ORIGINATION FORM

Proposed Revisions to a Standard Plans Index
(Please provide all information — Incomplete forms will be returned)

Index Number: 102-607
Sheet Number (s): 1
Index Title: Mobile Operations

LAST REVISION	11/01/20	DESCRIPTION:	 FY 2021-22 STANDARD PLANS	MOBILE OPERATIONS	INDEX 102-607	SHEET 1 of 2
---------------	----------	--------------	----------------------------------	-------------------	------------------	-----------------

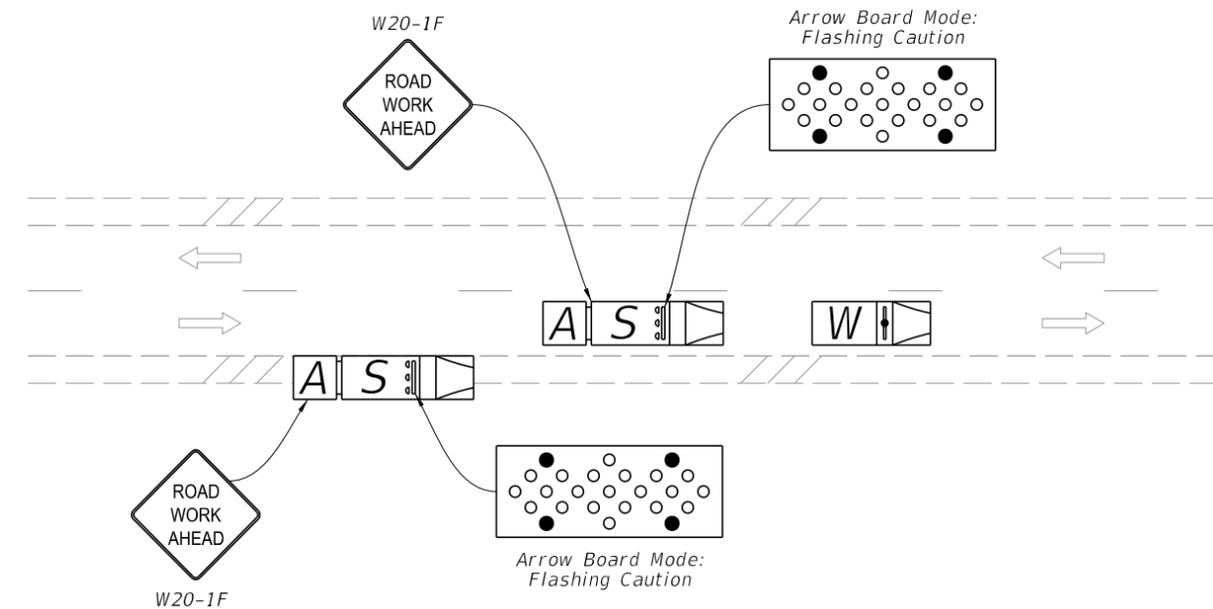
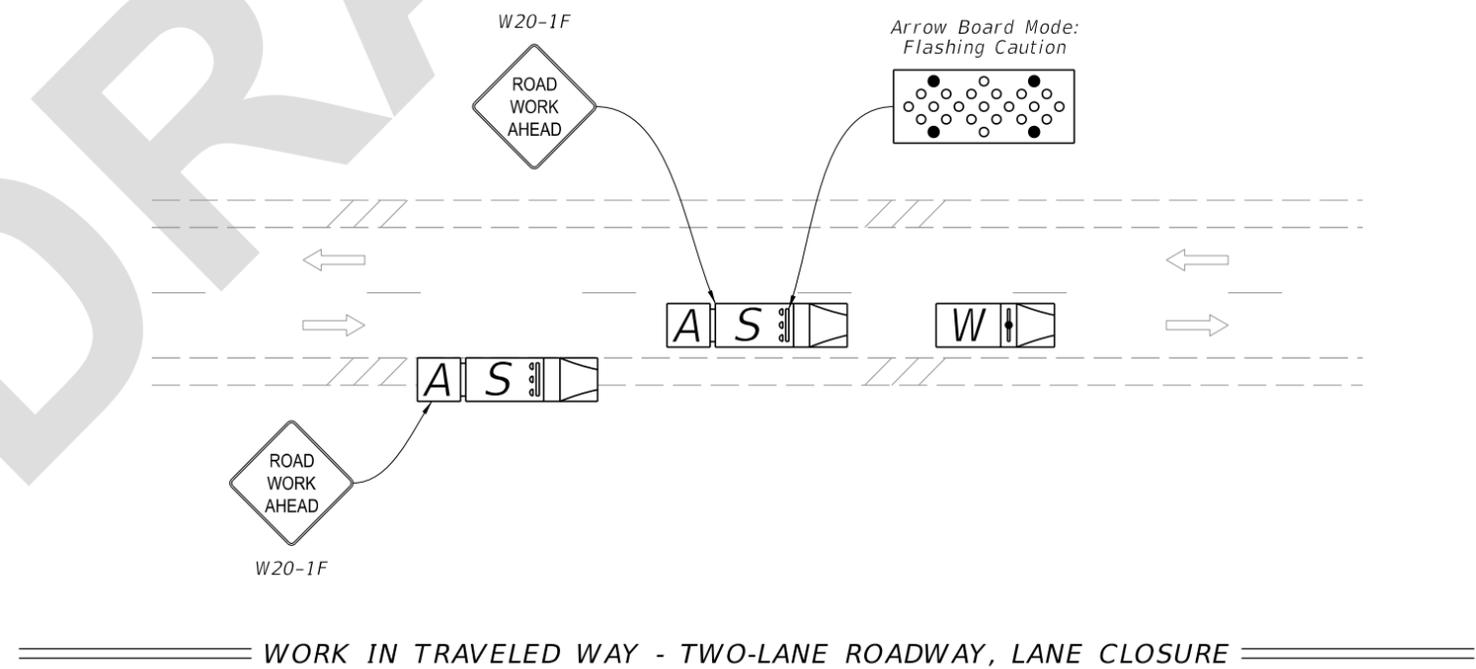
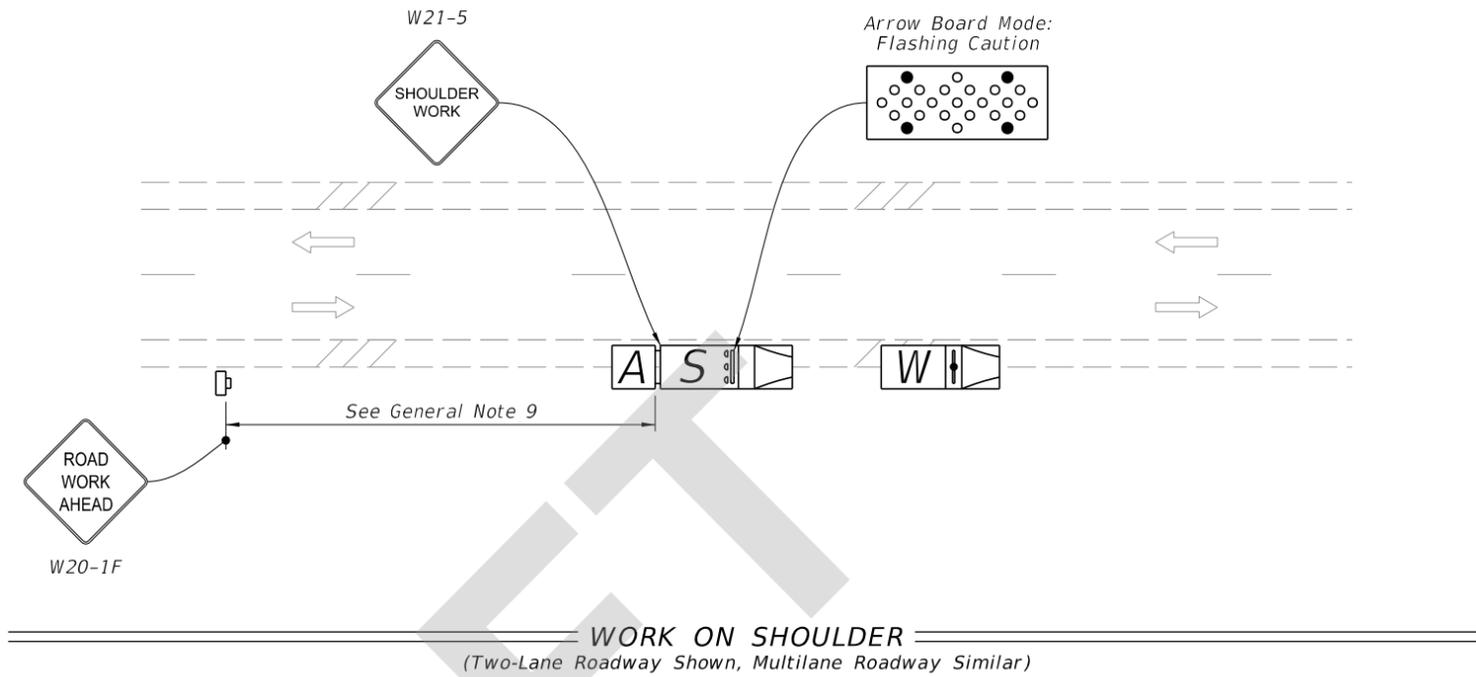
Sheet1: Changed General Note 4 to: Where work activities within 2' of the edge of traveled way are incidental (i.e., Mowing, Litter Removal), the Engineer may omit requirements for signs and the Shadow vehicle on the shoulder.

Delete the last part of Note 4 due to redundancy with Spec 102 that requires vehicles in the work area to have operating high-intensity rotating, flashing, oscillating, or strobe lights. Changed "delete" to "omit" in Note 4 to be consistence with the language in 102-602 Note 3.

- ~~4. Where work activities within 2' of the edge of travel way are incidental (i.e., Mowing, Litter Removal), the Engineer may delete requirements for signs and the Shadow vehicle on the shoulder provided vehicles in the work area have high intensity rotating, flashing, oscillating, or strobe lights operating.~~

CHANGED TO:
Where work activities within 2' of the edge of traveled way are incidental (i.e., Mowing, Litter Removal), the Engineer may omit requirements for signs and the Shadow vehicle on the shoulder.

4. Where work activities within 2' of the edge of travel way are incidental (i.e., Mowing, Litter Removal), the Engineer may omit requirements for signs and the Shadow vehicle on the shoulder.
